**REDSTONE GATEWAY PACKAGE H – MONUMENTAL
ARCHITECTURAL SIGNAGE**

**Project No. 65-12-SP22
April 19, 2012**

Addendum #2

Description Partial Mock-up sketch

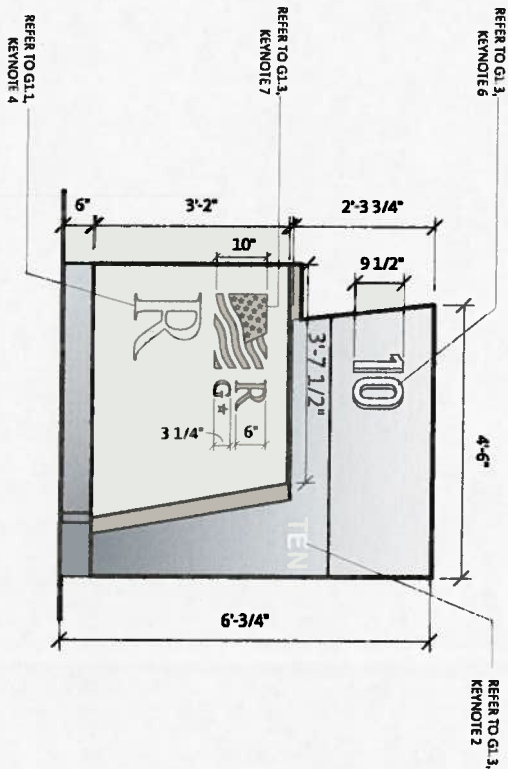
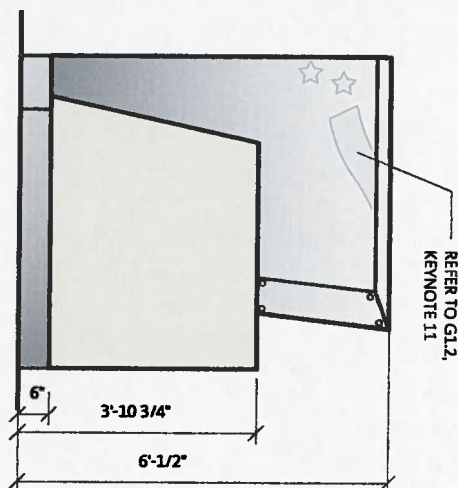
5. Q. Please provide more detail for the Mock-up?
A. See attached Partial Mock-up Sketch from Gensler dated 4/19/12. Please note the vinyl letters "TEN" will be required for the Mock-up only. No other vinyl letters are to be included in your bid per Q&A#3 above.

GENERAL NOTE:
MOCK-UP SHOULD BE A SECTION OF SIGN TYPE C, AND INCLUDE SAMPLES OF ALL SPECIFIED LETTERING TYPES, INCLUDING ALUMINUM LETTERING FROM SIGN TYPE A AND MASKED GRAPHIC FROM SIGN TYPE B
